DEVIATION REQUEST AND DECISION FORM

Project Name : CLOVERLEAF FILING NO. 2
Schedule No.(s) : 7124202236, 7124202239, 7123103007, 7124202238
Legal Description : SEE ATTACHED – Exhibit B

A deviation from the standards of or in Section **ECM section 2.3 Roadway Design** of the Engineering Criteria Manual (ECM) is requested.

Walters Point Cross Section

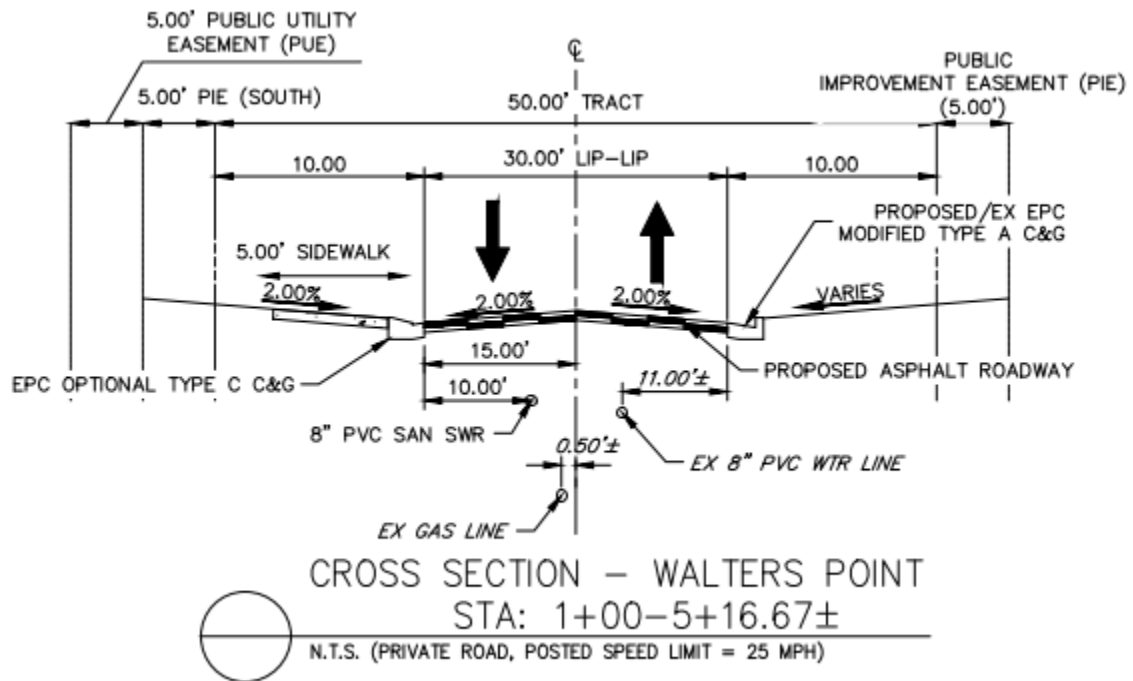
The developer requests a deviation from ECM table 2.7 – Local Roadway Design Standard be approved to delete the sidewalk on the north side of the roadway.

A deviation is requested to remove the sidewalk from the cross section on the north side of the road since Walters Point is an existing private roadway with no pedestrian walks adjacent to the private roadway, nor public walkways along Cloverleaf Road at its intersection with Walters Point.

See Exhibit A for a graphical representation of the roadway cross section.

This request has been determined to have met the criteria for approval. A deviation from Section 2.3 of the ECM is hereby granted based on the justification provided.
